# SERVICE BULLETIN

M-1382

## 2014 FL TOURING HYDRAULIC CLUTCH - SAFETY RECALL CODE 0159

Figure 1. Recall Kit 91500068

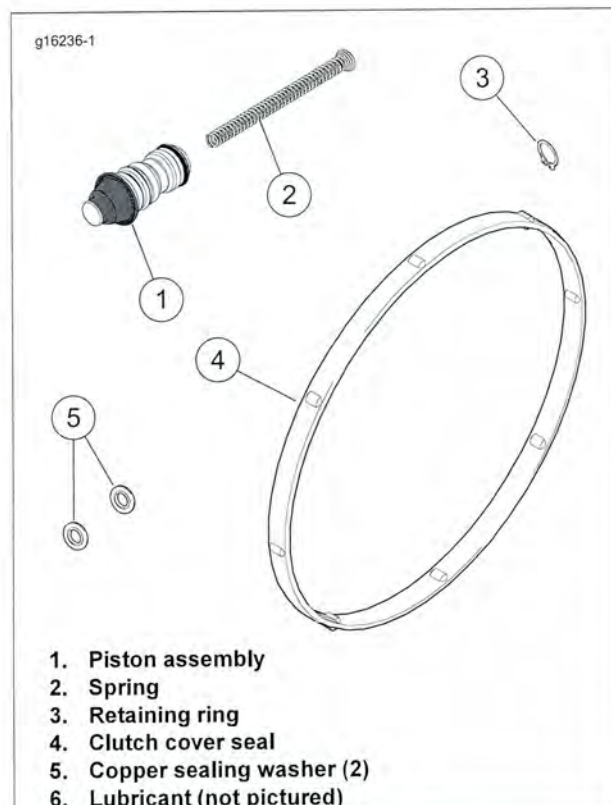
1. Confirm that the motorcycle is involved in Recall 0159. If the status includes an **open** for Safety Recall 0153, the 0159 should be performed and the 0153 will be closed by HDMC once the 0159 claim is approved.
2. Obtain the recall kit (Part No. 91500068).
3. Replace the clutch master cylinder piston assembly with parts from the recall kit. This kit is to be used on both original equipment clutch master cylinders and chrome accessory clutch master cylinders (Part No. 41700263 and 41700263A). See CLUTCH MASTER CYLINDER AND RESERVOIR in the service manual.
4. Fill and bleed clutch fluid system. See the service manual.

Do not reuse any parts removed from the master cylinder piston bore. Use only the parts from the kit.
